HISTORIC AND DESIGN REVIEW COMMISSION

March 20, 2019

HDRC CASE NO: 2019-095
ADDRESS: 1122 N PINE ST
LEGAL DESCRIPTION: NCB 1300 BLK 1 LOT 3
ZONING: R-5, H
CITY COUNCIL DIST.: 2
DISTRICT: Dignowity Hill Historic District
APPLICANT: Martin Da La Garza/Arki Design Homes
OWNER: Tarun Gajera/ADITYA GAJERA LLC
TYPE OF WORK: Front and Rear Additions
APPLICATION RECEIVED: February 18, 2019
60-DAY REVIEW: April 17, 2019
REQUEST:

ELEVATION &
SITE PLAN

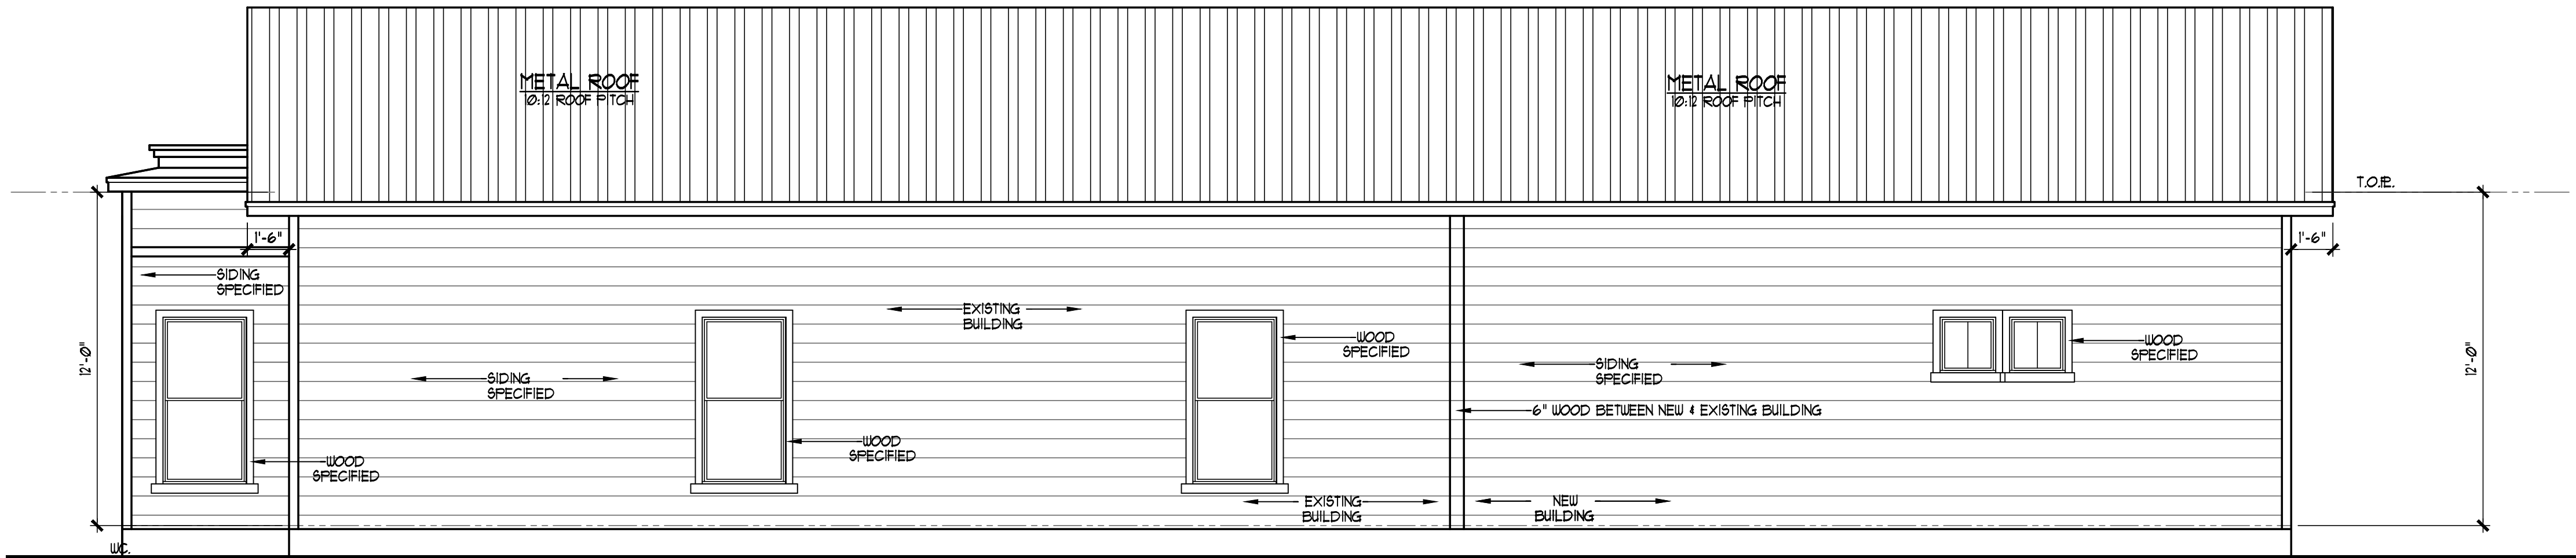
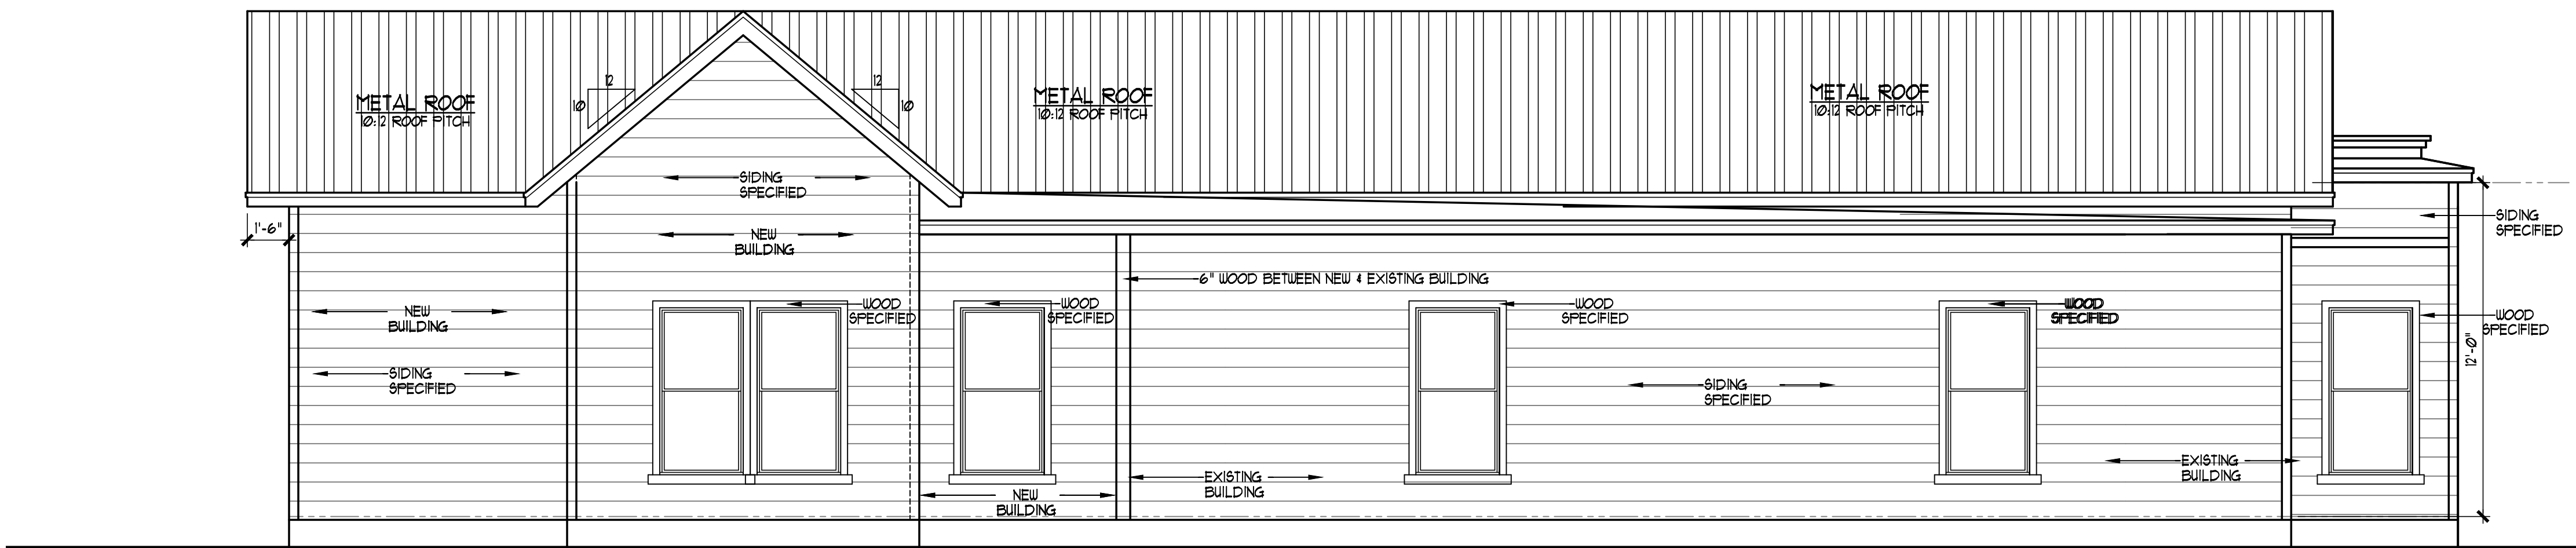
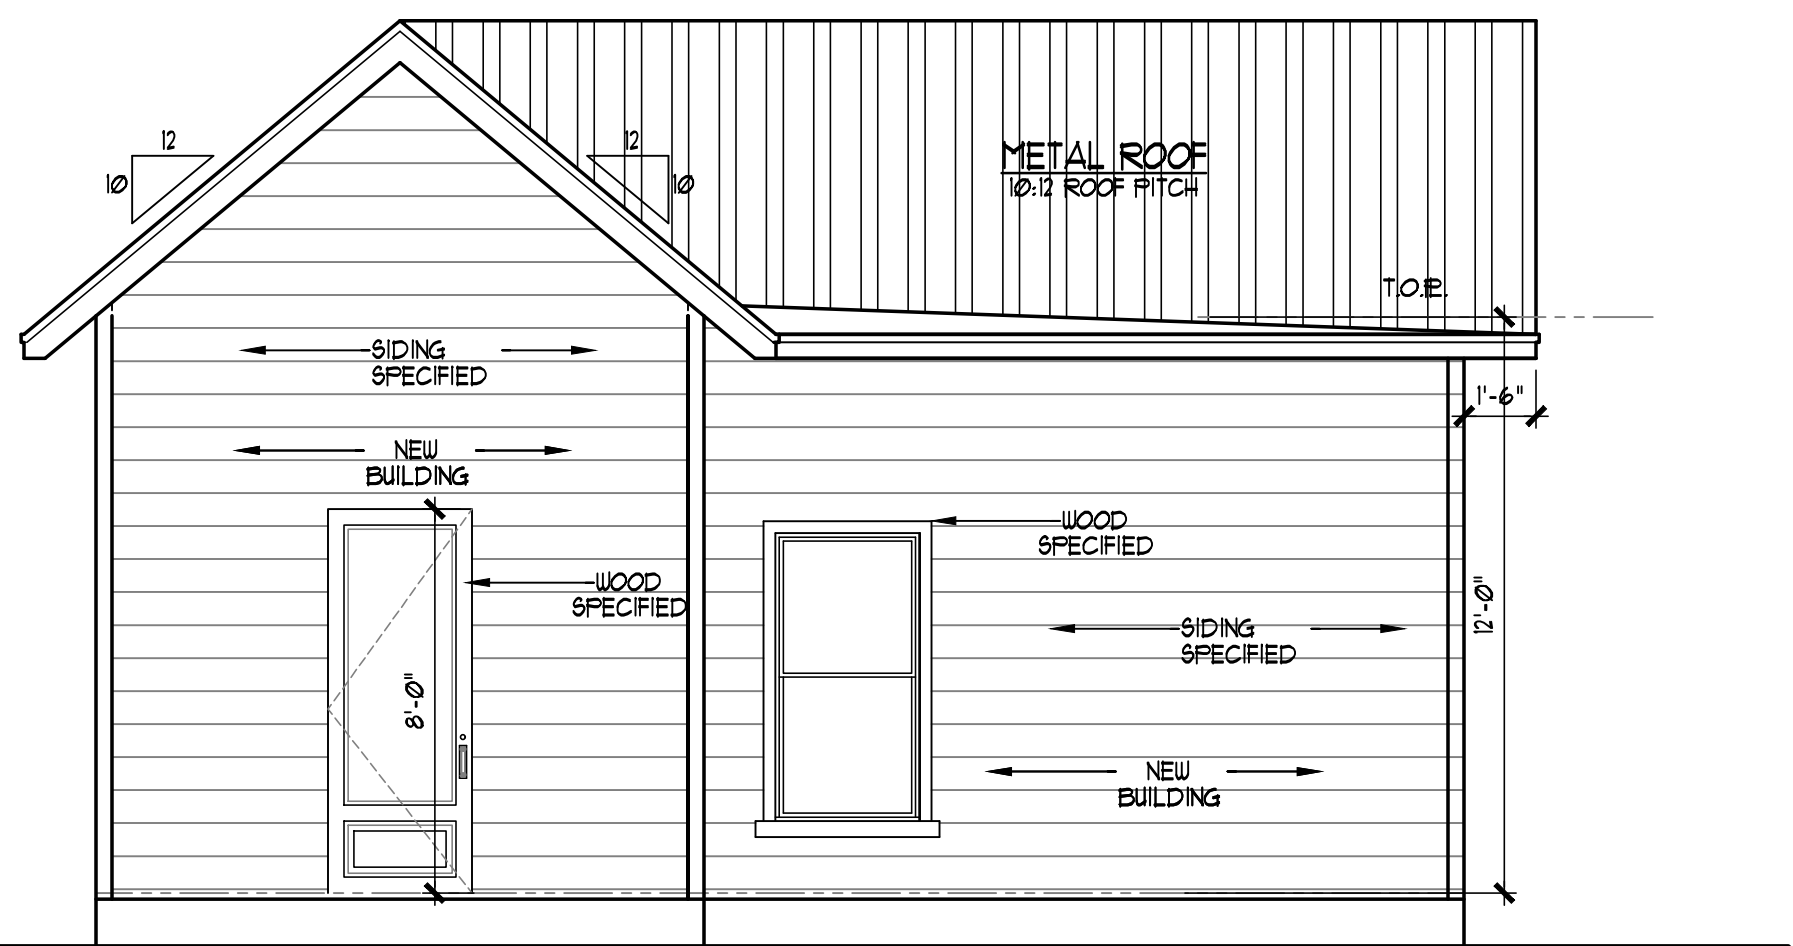
- b. FRONT ADDITION – The applicant has proposed to install a front addition featuring approximately 200 square feet by modifying the existing plan front porch enclosure into a rectangular room with a shed roof. Per the Guidelines for Additions 3.1.A., an addition to the front of a building would be inappropriate. Furthermore, staff finds that this structure's original L-plan was uncommon to the Folk Victorian configurations found in the historic district and is a character-defining feature that should be preserved. Staff finds that the enclosure non-conforming front porch should be repaired in-place or restored to its original open porch configuration.

- c. REAR ADDITION – The applicant has proposed to install a rear addition featuring approximately 700 square feet. The proposed addition will feature matching roof material and pitch, wood siding, and sashed wood window with two square sliding windows.

- e. TRANSITION BETWEEN NEW & OLD – The proposed rear addition features matching siding and roofing with a vertical trim piece to distinguish between new and old forms. Per the Guidelines for Additions, a setback or recessed area and a small change in detailing at the seam of the historic structure and new addition should be used to provide a clear visual distinction between old and new building. Staff finds that the proposed vertical trim piece as opposed to the setback condition would suffice in distinguishing between forms while preserving the linear configuration of the original front-facing gable.

- f. MATERIALS – The applicant has proposed to use matching roofing material and wood siding to the original structure. Per the Guidelines for Additions 3.3.A.i, materials should match in type, color, and texture and include an offset or reveal to distinguish the addition from the historic structure whenever possible. Any new materials introduced to the site as a result of an addition must be compatible with the architectural style and materials of the original structure. Portions of new standing seam-metal roof should feature the standard stipulations: *18 to 21 inch wide panels, seams 1 to 2 inches tall, a crimped or double munched seam with no vented ridge caps, and a standard galvalume finish or painted to match the historic roof.* Portions of new siding may be constructed with wood or

Hardie in the same profile, configuration, and lap exposure as the existing siding; faux wood grain texture should not be used. Staff finds that the shake shingle on the rear gable should be preserved and relocated in a matching configuration to the addition's rear gable.

1. Staff does not recommend approval of the front addition based on finding b. Staff recommends the applicant repair the non-original enclosed front porch in-place or restore the porch to its original open configuration with additional staff review.

2. Staff recommends conceptual approval of the rear addition based on findings c through g with the following stipulations to be addressed prior to submitting for final approval:

- i. **ROOF FORM** - The addition's roof should feature an extension of the primary front-facing gable with a shed roof extending from the turned gable. No portions of gabled roofing should be demolished. The shake shingles on the existing rear gable should be relocated to the addition's rear gable in the same configuration. A site plan including the proposed roof form should be submitted to staff.

- ii. **ROOFING MATERIAL** - The addition's roof should feature the standard specifications for new standing seam metal roofs: *18 to 21 inch wide panels, seams 1 to 2 inches tall, a crimped or double munch seam with no vented ridge caps, and a standard galvalume finish or painted to match the historic roof.* An inspection should be schedule with staff prior to installation.

- iii. **NEW WINDOWS** - The addition's windows should feature the standard specifications for new windows: *Meeting rails that are no taller than 1.25" and stiles no wider than 2.25". White manufacturer's color is not allowed, and color selection must be presented to staff. There should be a minimum of two inches in depth between the front face of the window trim and the front face of the top window sash. This must be accomplished by recessing the window sufficiently within the opening or with the installation of additional window trim to add thickness. Window trim must feature traditional dimensions and an architecturally appropriate sill detail. Window track components must be painted to match the window trim or concealed by a wood window screen set within the opening.*

- iv. **FENESTRATION** - Final window and door specifications should be submitted to staff. The door should feature a Folk Victorian style or a simple 6-panel design. No window or door opening on the existing historic structure should be removed without consultation with staff followed by an approval.

- v. **SIDING** - The addition's siding should feature Hardie or wood siding that matches the existing in profile, configuration, and lap exposure. Faux wood grain texture should not be used.
